## ON-SITE SEWAGE DISPOSAL SYSTEM HOWARD COUNTY HEALTH DEPARTMENT BUREAU OF ENVIRONMENTAL HEALTH

SUBDIVISION: Avery Property LOT NUMBER: 8

ADDRESS: 14431 Frederick Road Darryl Hockstra Jr.

WALL CHECK  
AVERY PROPERTY  
LOTS 4-8 AND  
PRESERVATION PARCELS 'A'-'C'  
LOT No. 8

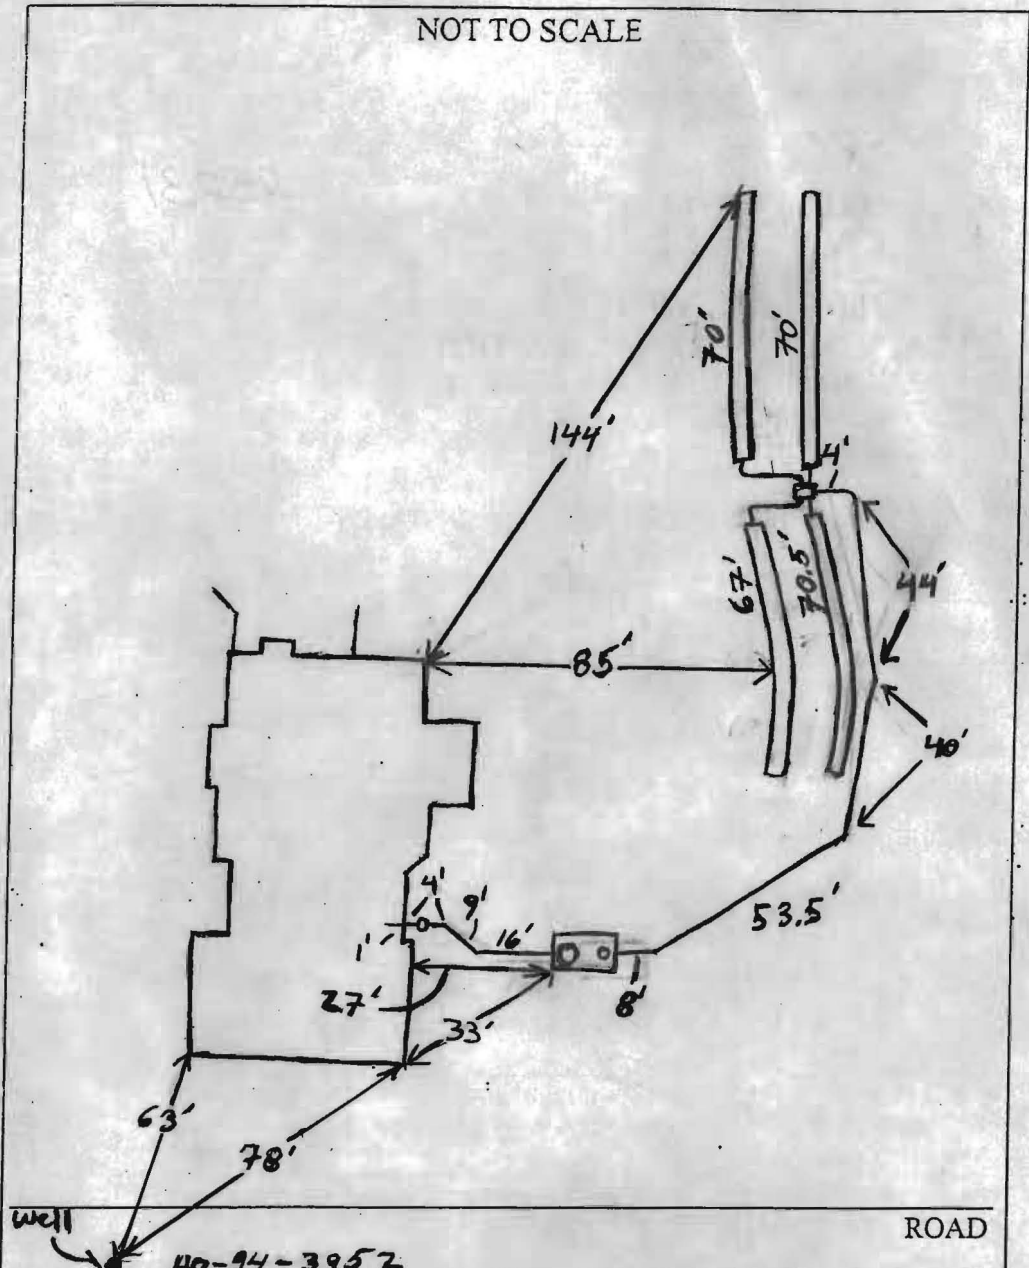
PUMP CHAMBER CAPACITY (GALLONS): ~~1500~~ ~~COMPARTMENTED TANK REQUIRED~~

TRENCHES: <u>7</u>	Trench to be 3.0 feet wide. Inlet <del>4.0</del> <u>5'</u> feet below original grade. Bottom maximum depth <del>6.0</del> feet below original grade. Effective area begins at 4.0 feet below original grade. 2.0 feet of stone below distribution pipe.
LOCATION:	Place distribution box as shown on the approved building permit plan. To maximize are run >248' of trench; 3 (70') and 1(60') length of trench.
	Septic easement must be staked out for layout inspection. Prior to filling trench with #2 stone, call for an inspection. Ensure no more than 3' cover on septic tank lids. <b>SEPTIC AREA MUST STAY RIBBONED OFF TO PREVENT EARTH DIKE FROM ENCROACHMENT.</b>

PRE-CONSTRUCTION 9/7/06 Changed inlet to 5.5' and bottom depth to 7.5'. Told contractor that he needs a 2 compartment tank.

INSTALLATION Install 4 (60'-70') trenches on contour from the top center of the easement. Keep trenches inside easement. (BB)

9/12/06 All trenches installed per plan w/ 5'6" inlet on all 4 trenches. Trenches installed on contour. OK. to Backfill. (KW)

~ FOUNDATION DETAIL ~  
SCALE: 1" = 30'

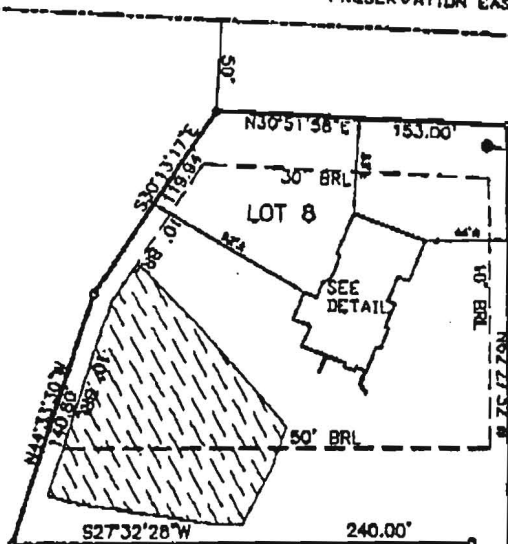
8/24/06  
wall check  
OK (SO)
